### *Map Correction-Field Verification*

**Drain Number:** #203

**Drain Name:** Masthead: Section 12

### *Map Correction-Field Verification*

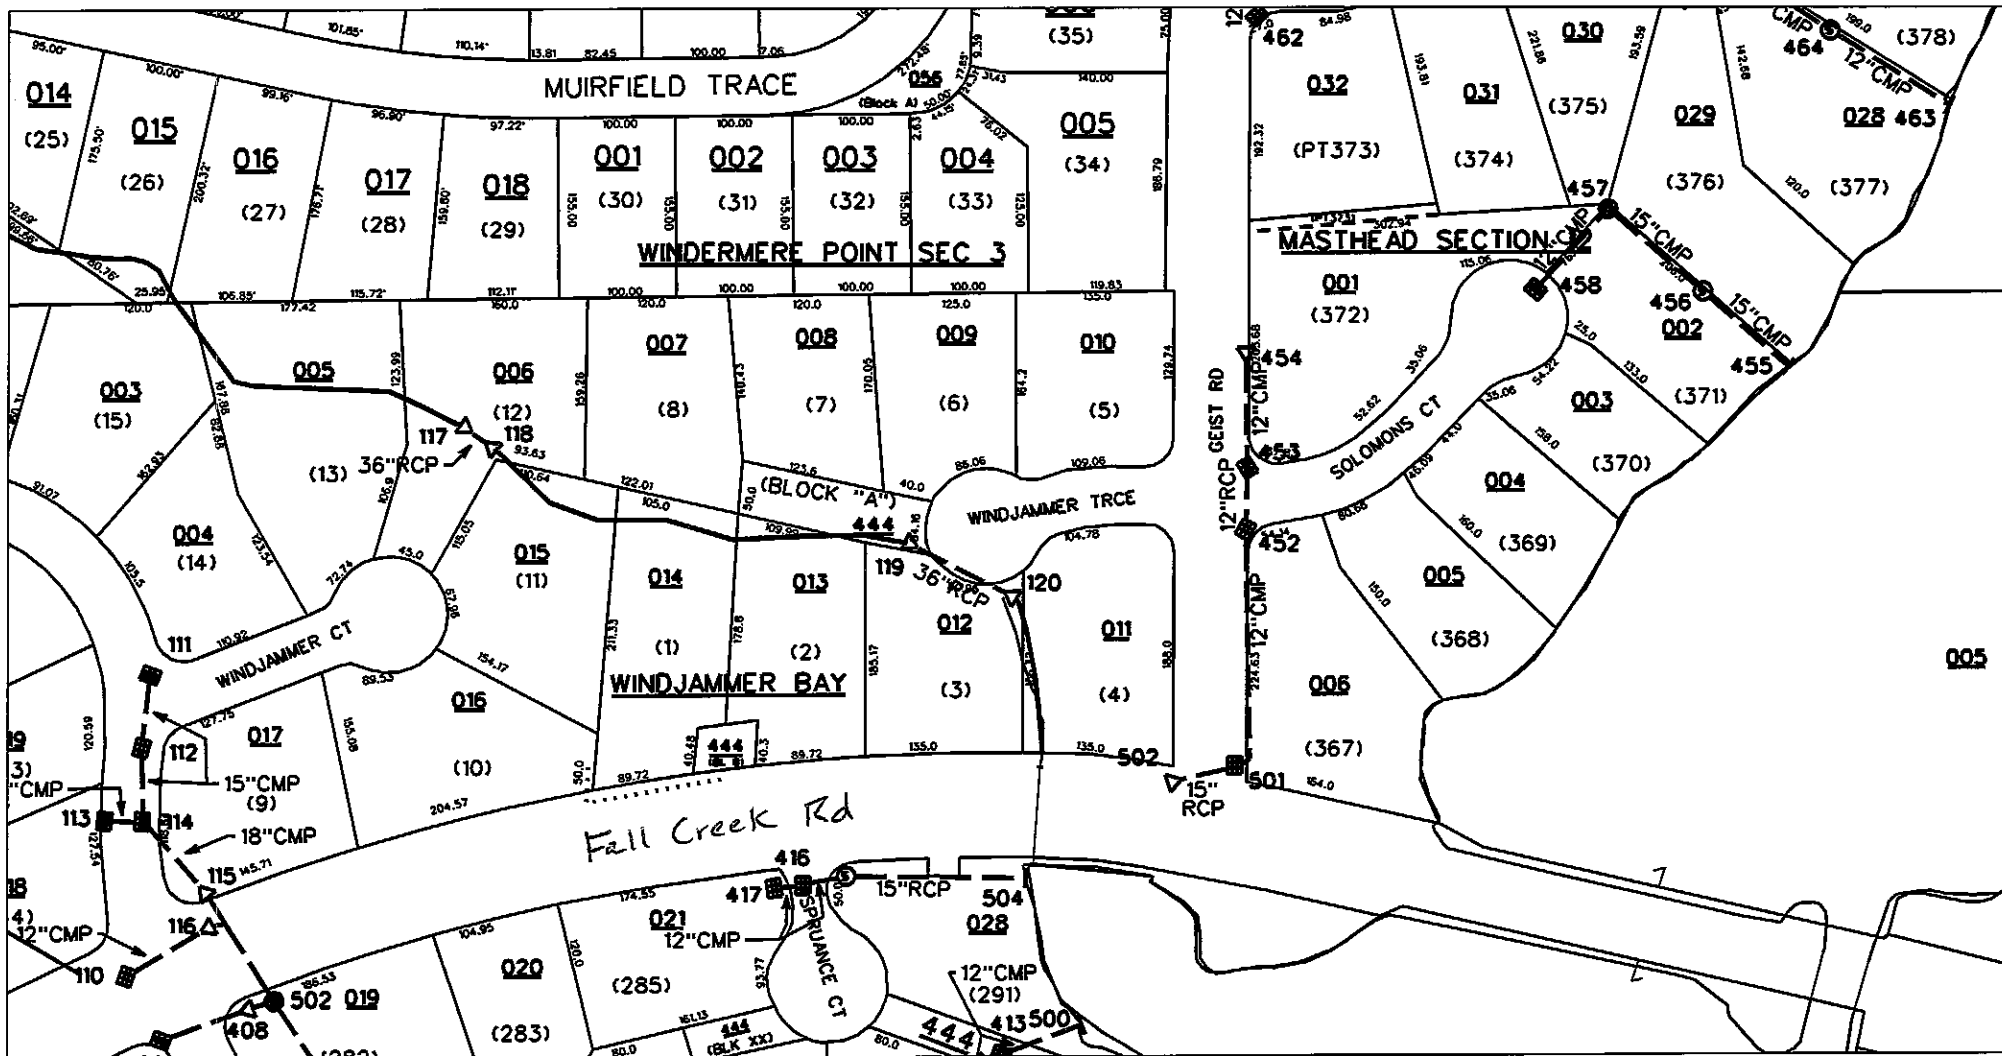
The outlet was modified with the Fall Creek Rd improvements and therefore, the open ditch was removed from structure 451 to Geist Reservoir. The drain was then re-routed through a new 15" RCP on the opposite side. Existing structure 451 was removed and structures 501 & 502 were added. See the attached map.

TECH. CHK.	DRAWN BY JG	SCALE 1" = 50'	DATE 6-27-84	CLIENT MASTHEAD - SEC. 12	DV
DFTNG. CHK.	DRAWING TITLE SITE DEVELOPMENT PLAN - SOUTH HALF				8

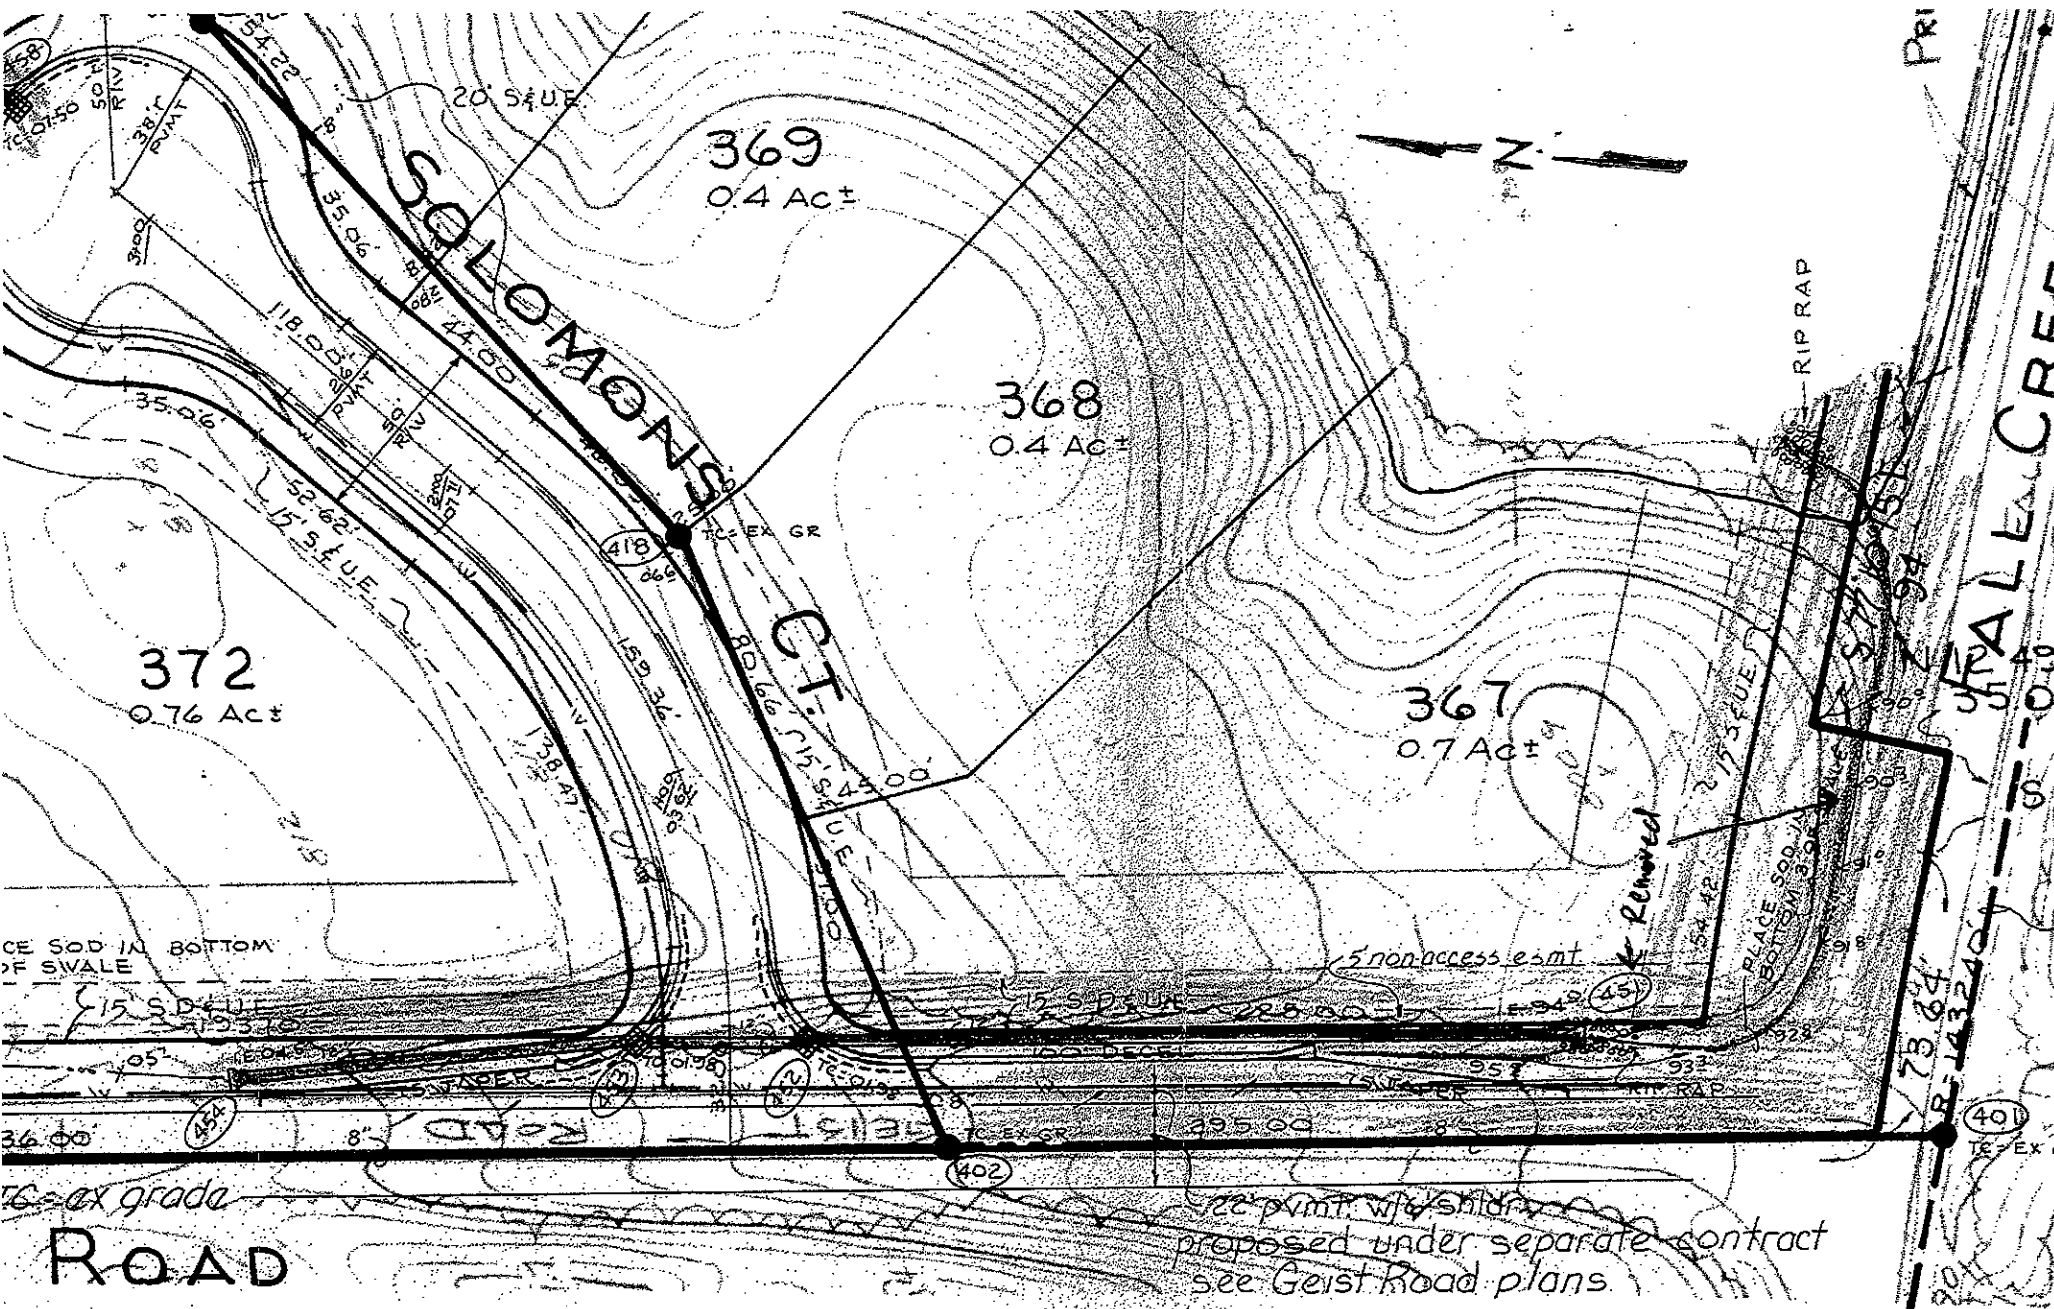
**Notes & Sketch:** (See attached Plan) \*note that Str. 482 was given a solid lid.

It was brought to our attention that our mapping had not been updated to reflect a change to Lots 411,412 (Sec. 12) and lots 418,442 (Sec. 13). On March 12, 1990 drainage plans and Calculations were submitted to upgrade the existing drainage facilities across these lots. The upgrade was recommended by Shorewood and Paul I Cripe, Inc. (Job # 84100-00012) in order to alleviate flooding upstream of the existing pipe.

As the attached plan reflects, the contractor installed 225 feet of 24" RCP and 390 feet of 36" RCP to parallel\* the existing 33" RCP. It should also be noted that at some point a seawall was installed at the outlet and was again modified about the same time the additional pipes were added. (See violation letter dated February 27, 1990)
